PCN-20210613 TE0783-02 eMMC Change and Product Update

Company	Trenz Electronic GmbH
PCN Number	PCN-20210613
Title	TE0783-02 eMMC Change and Product Update
Subject	BOM change
Issue Date	2021-09-09

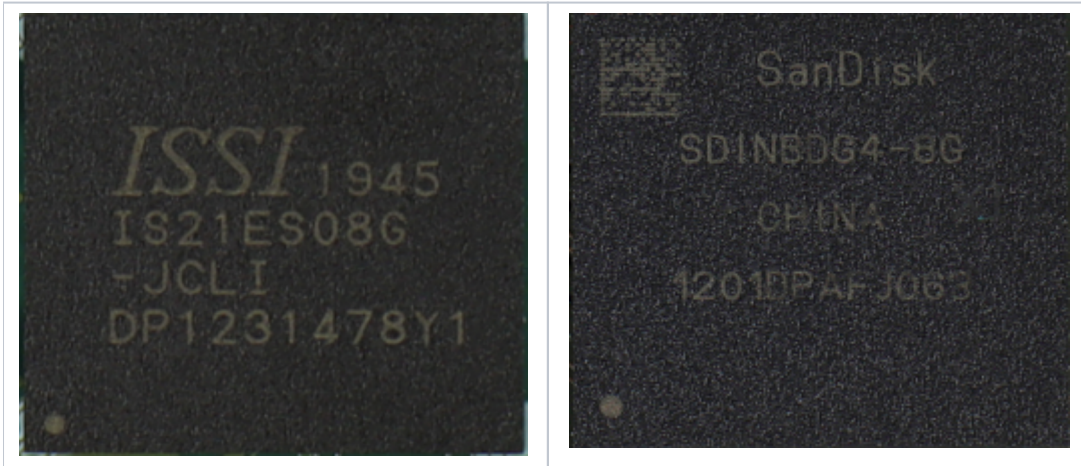
#4 Set S/N to not fitted

Reason: Part is end of life.

Impact: Track it pad no more available.
